SERVICE BULLETIN

RM 8405, RM 8505, RM 8555, RML 8555, RMS 8405, RMS 8465, RMS 8505, RMS 8555

Software AES 8er-Serial

Fig. 1

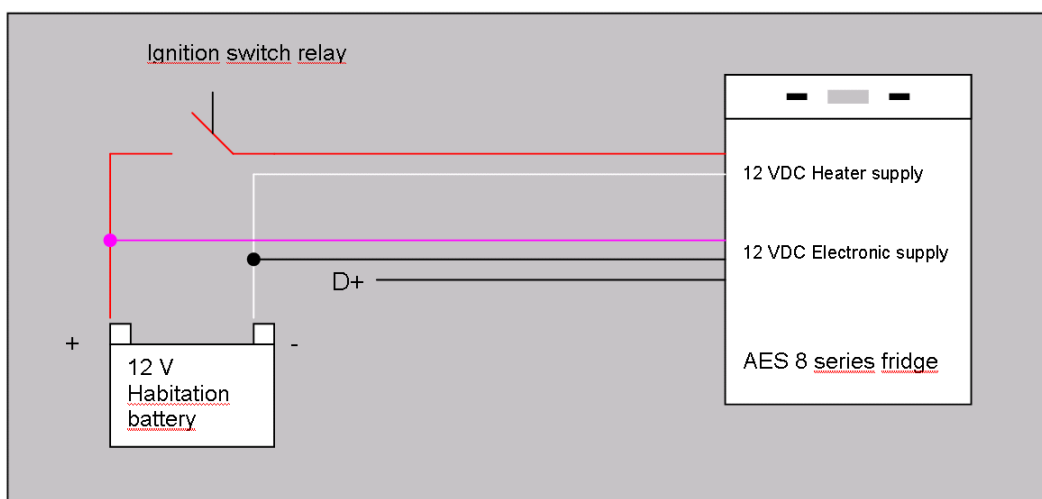
It might happen, that fridges mentioned above up to serial number 801xxxxx do not switch to DC in automatic mode, while the engine of the vehicle is running.

This happens, if the +12V DC heater wire is switched with a ignition relay and get the D+-signal at the same time (Fig. 1).

Fig. 2

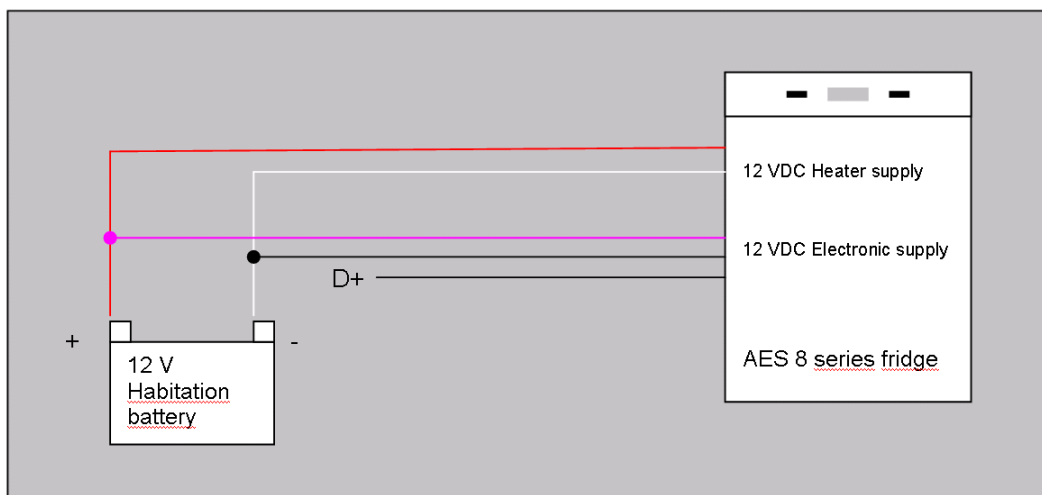
This problem could be solved by rewiring (Fig. 2)

The actual electronics, spare part number 241 3423-10/0 are changed, now the electronics works at both kinds of wiring.
